# Access Compliance Report

## Public Rights-of-Way

Intersection ID: 3565	Main Street: ROTHERHAM_LN	Cross Street: TREYBURN_DR	Location: N
ADA ID: 54360CF6AE96	Ramp Type: Perp	Initial Pass/Fail: Fail	Overall Compliance: No
			Severity Score: 13.75

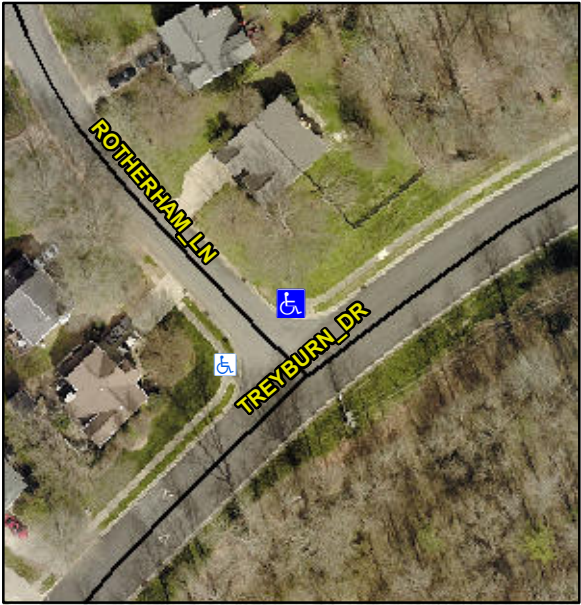
Codes/Mitigation Info/Possible Solution			Field Measurements/Component Compliance		
	Possible Solutions:		<b>Compliance</b>	<b>Description</b>	<b>Data</b>
	<b>Remove &amp; Replace Entire Ramp.</b>		<b>No</b>	Ramp Length (in)	<b>95.0</b>
			<b>Yes</b>	Ramp Width (in)	<b>48.0</b>
			<b>N/A</b>	Flare Type LT	<b>N/A</b>
			<b>N/A</b>	Flare Slope LT (%)	<b>N/A</b>
			<b>N/A</b>	Flare Traversable LT?	<b>N/A</b>
			<b>N/A</b>	Landing Length (in)	<b>N/A</b>
			<b>N/A</b>	Landing Width (in)	<b>N/A</b>
			<b>N/A</b>	Landing Slope (%)	<b>N/A</b>
			<b>N/A</b>	Landing X Slope (%)	<b>N/A</b>
<p>Surveyor Notes:</p> <p><b>N/A</b></p> <p>PROW/ADA:</p> <p><b>Not Found, R304.2.2, R304.5.3</b></p>			<b>N/A</b>	Flare Type RT	<b>N/A</b>
			<b>N/A</b>	Flare Slope RT (%)	<b>N/A</b>
			<b>N/A</b>	Flare Traversable RT?	<b>N/A</b>
			<b>N/A</b>	DWS Provided?	<b>N/A</b>
			<b>N/A</b>	DWS Contrast?	<b>N/A</b>
			<b>N/A</b>	DWS Length (in)	<b>N/A</b>

<b>N/A</b>	DWS Full Width?	<b>N/A</b>
			<b>N/A</b>	DWS Offset (in)	<b>N/A</b>
			<b>N/A</b>	Gutter Ponding?	<b>N/A</b>
			<b>N/A</b>	Gutter Lip Ht (in)	<b>N/A</b>
<p>Total Cost:</p> <p><b>\$ 1850.00</b></p>			<b>No</b>	Painted X Walk2?	<b>N/A</b>
			<b>To SW</b>	X Walk 2 Direction	<b>N/A</b>
			<b>N/A</b>	X Walk 2 Width (in)	<b>N/A</b>
			<b>0.2</b>	X Walk 2 Slope (%)	<b>N/A</b>
			<b>0.7</b>	X Walk 2 X Slope (%)	<b>N/A</b>
			<b>N/A</b>	Ramp inside XWalk2?	<b>N/A</b>
			<b>N/A</b>	Clear Space?	<b>N/A</b>
			<b>N/A</b>	Clear Space to XWalk (in)	<b>N/A</b>
			<b>N/A</b>	Storm Grate/Utility Hazard?	<b>N/A</b>
			<b>N/A</b>	Storm Grate/Utility Type	<b>N/A</b>
			<b>N/A</b>		<b>N/A</b>
			<b>Yes</b>	Surface Condition? (G/P)	<b>Good</b>
